Product Discontinuation Notices

Product Discontinuation

CJ1W-ETN21

CJ1W-EIP21S

Product discontinuation	Recommended replacement1
CJ1W-ETN21	CJ1W-EIP21S

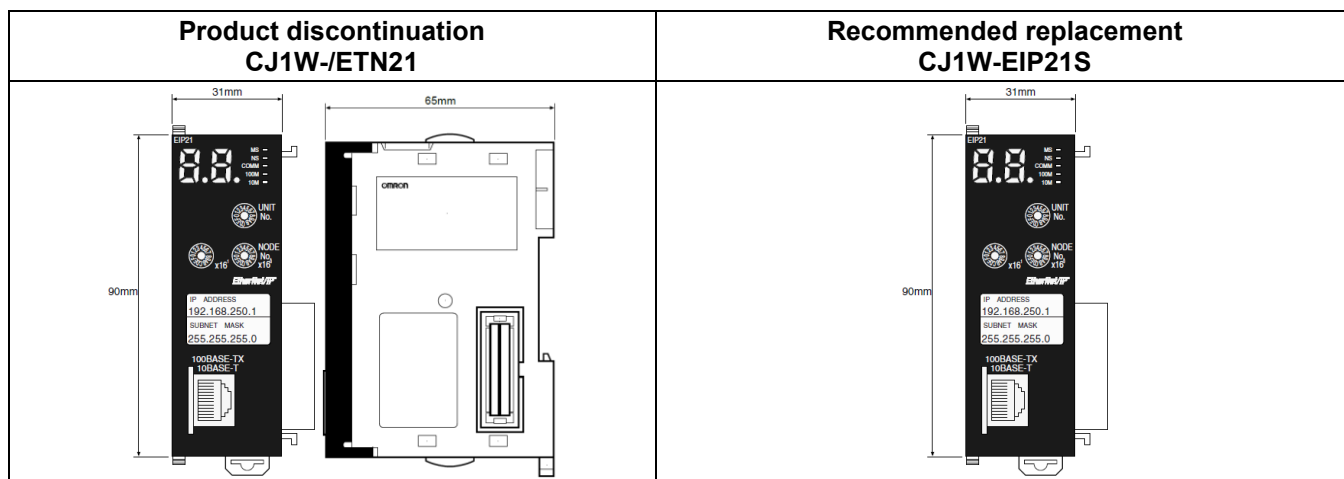
[Differences Compared to the Discontinued Product]

Recommended replacement Model	Body Color	Dimensions	Wire connection	Mounting Dimensions	Characteristics	Operation ratings	Operation methods
CJ1W-EIP21S	**	**	**	**	*	*	*

Item	Product discontinuation CJ1W-ETN21	Recommended replacement CJ1W-EIP21S
Weight	94 g max.	91 g max.
Current consumption	0.37 A at 5 VDC	0.65 A at 5 VDC
Applicable Controllers	CJ Series/CP1H Series/NJ Series	CJ Series/CP1H Series/NJ Series
Security function	Not available	Available
Online connection from CX-One via EtherNet/IP port with secure communications	Not available	Available
Tag data link communications service	Not available	Available
CIP message communications service	Not available	Available
Mail send/receive	Available	Not available
Web functions	Available	Not available
Monitoring Unit Control Bits with CX-Programmer	Possible	Not possible

When replacing the unit within the CJ series, please consult the replacement guide and relevant manuals before designing the system.

Ethernet Units -> Enhanced Security Units Replacement Guide (Cat. No. P152)
